Proposal for Amendment to Regulation 78 (Uniform provisions concerning the approval of vehicles of categories L₁, L₂, L₃, L₄ and L₅ with regard to braking)

Submitted by the expert from International Motorcycles Manufacturers Association

The text reproduced below was prepared by the expert from IMMA in order to introduce amendments to clarify the text in this regulation and align it with gtr 3. The modifications to the current text of the Regulation are marked in bold or strikethrough characters.

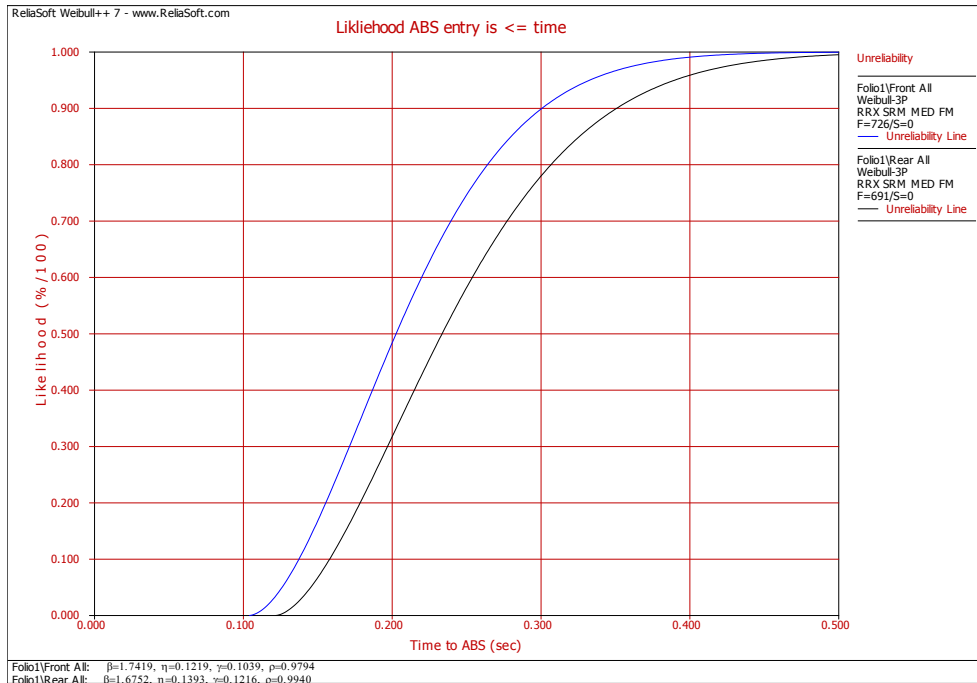
The brake control actuation force is applied in ~~0.2~~ **0.1** – 0.5 secs.

It has been noticed in testing that the brake application rate specified in section 9.5.1 can result in a large number of test failures. It can be seen in the chart below that the 0.2 second lower limit shows a failure rate is between 30% and 50% of the time.

By reducing the lower limit to 0.1 seconds the test failure rate reduces to practically zero. Allowing the reduction tends to make the regulation more stringent by including a greater number of brake force application rates and eliminates restrictive test requirements.
